INSPECTION REPORT  
Sedimentation Structure  
WW-6  
Black Mesa Mine  
Navajo County, Arizona  
for  
PEABODY COAL COMPANY

Dames & Moore  
10139-011-22

CHANNEL PROFILE B-B'  
WW-6

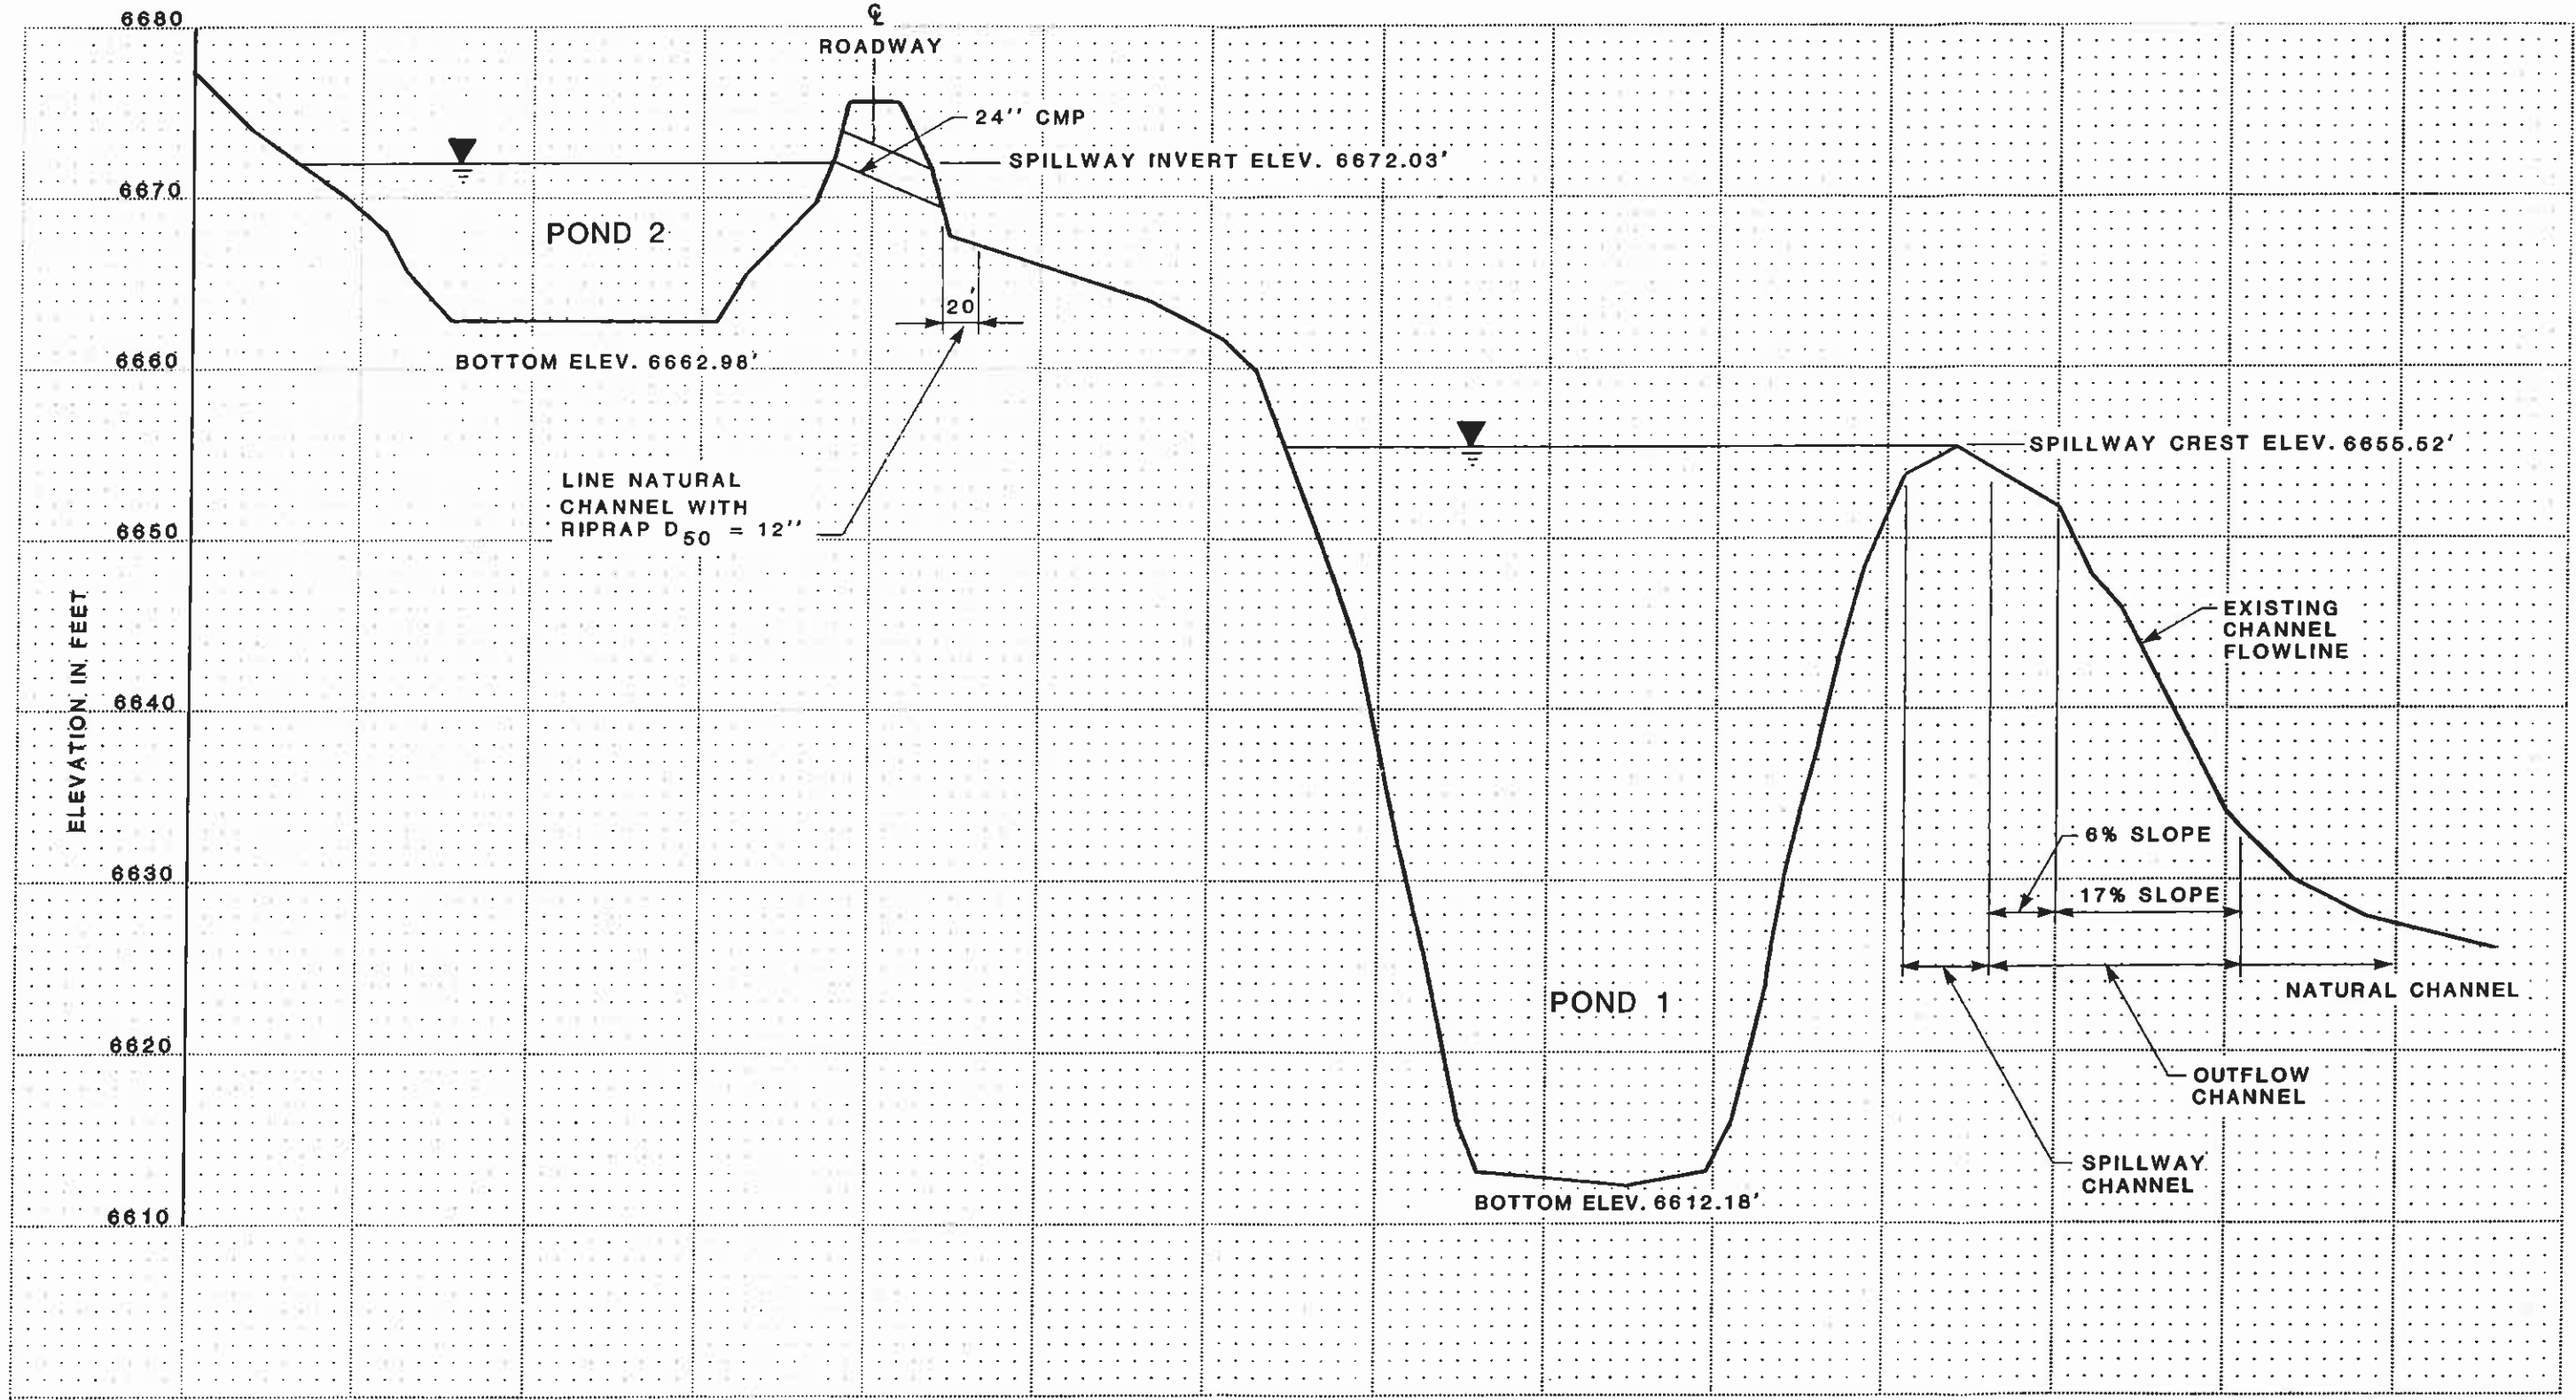
A trashrack should be installed on the inlet of the spillway pipe for Pond 2. The natural channel below the pipe should be lined with riprap to prevent erosion (see Plate 4).

**SPILLWAY CHANNEL  
 CROSS SECTION  
 WW-6**

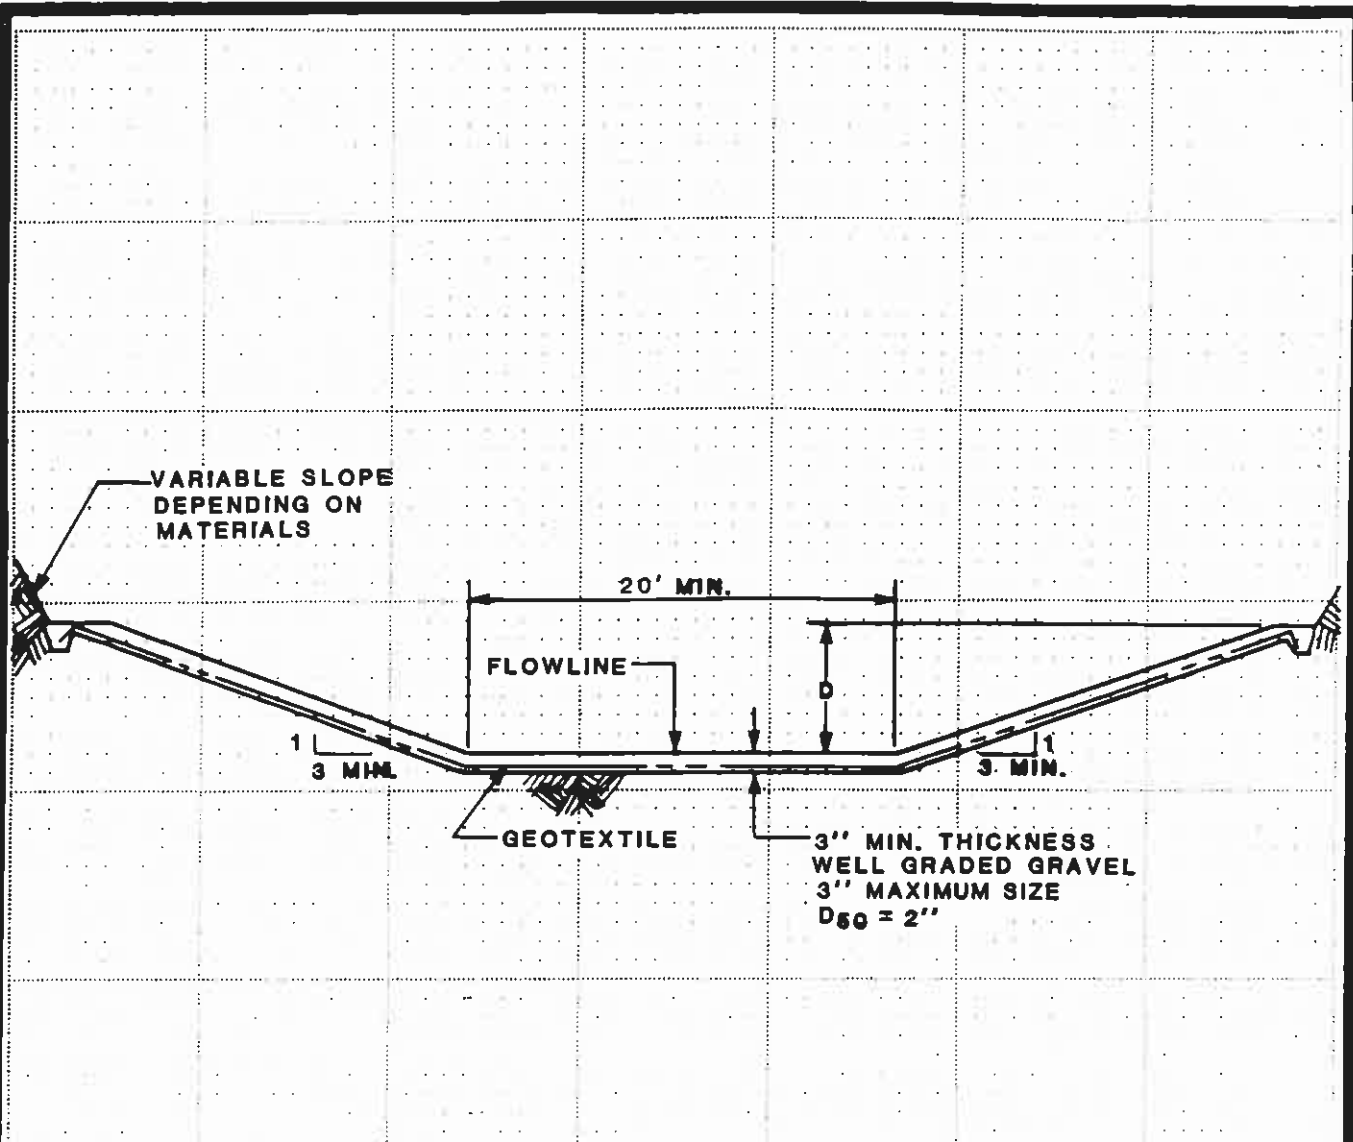
The storage capacity and spillway capacity of Structure WW-6 are adequate. The outflow channel of Pond 1 is protected with riprap but the spillway channel is not. The spillway channel should be protected against erosion using geotextile and gravel as shown in Plate 5. Plate 4 shows the existing spillway and outflow channel profile and Plate 5 shows the channel dimensions.
